Work Order ID 51867

Item Name: Rib

D3265-041 BASKET BASE ASSEMBLY

DRAWING NO. D3265	TITLE BASKET BASE ASSEMBLY (350)	REV. C	DART AEROSPACE LTD ENGINEERING ORDER		D.E.O. NO. D3265-C-1	SHEET NO. SHEET 1 OF 2	SCALE NTS
DRAWN <i>[Signature]</i>	CHECKED <i>PH</i>	MFG. APPR. <i>[Signature]</i>	APPROVED <i>[Signature]</i>	DE APPR. <i>[Signature]</i>			
DATE 09.04.16	DATE 09.04.16	DATE 09.04.16	DATE 09.04.16	DATE 09.04.16	DATE 09.04.16

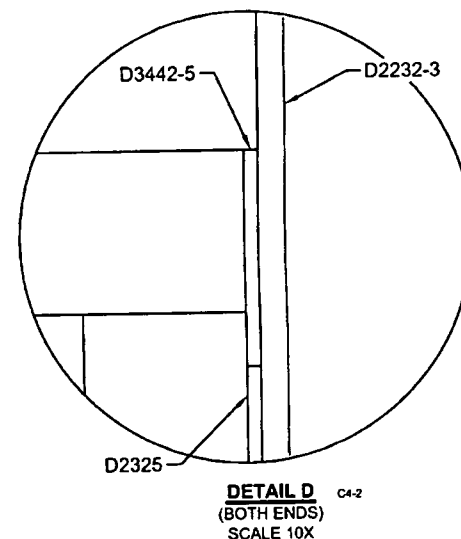
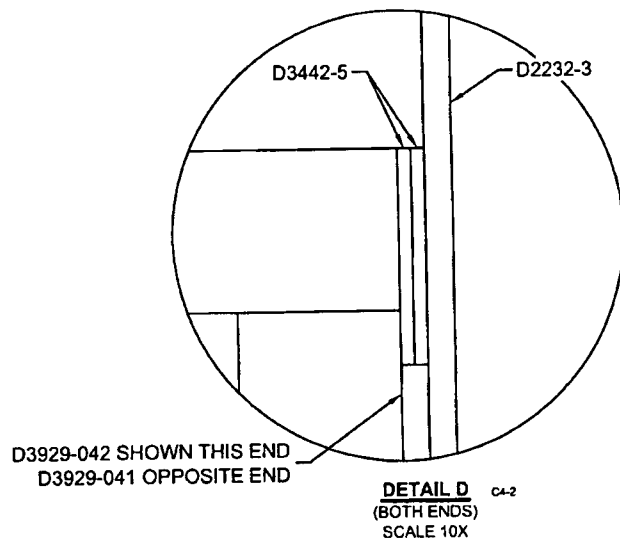
SHEET 2, MODIFY DETAIL D AS SHOWN:

SECTION A-A AS-2
2 PL
(BOTH END RIBS)

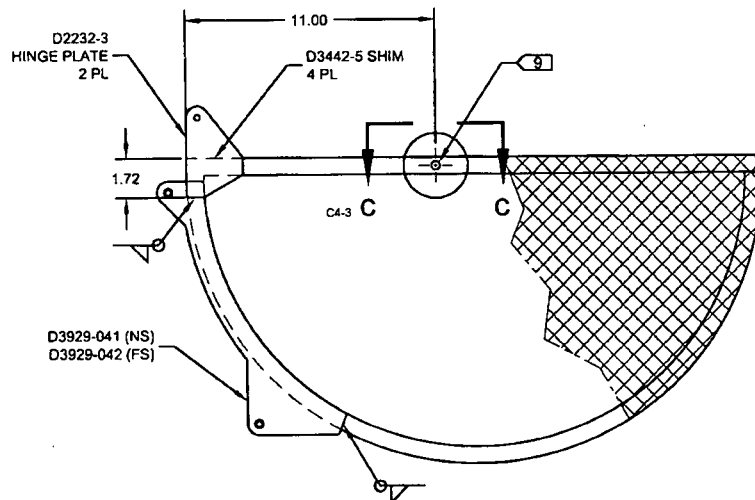
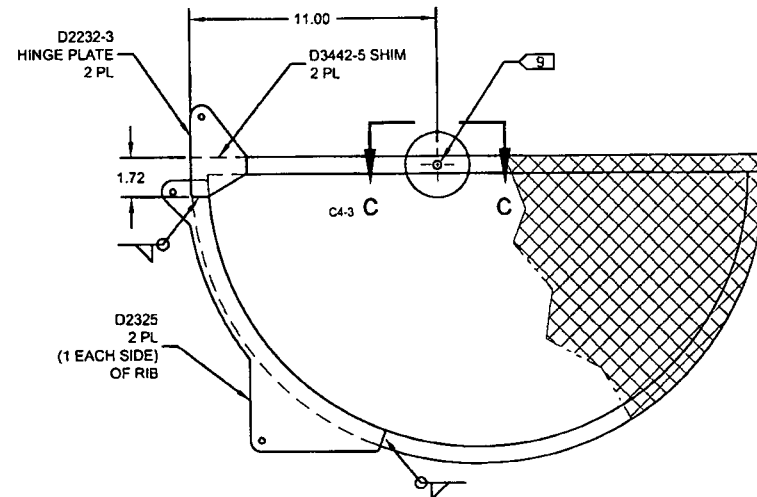
SHEET 3, MODIFY SECTION A-A AS SHOWN:
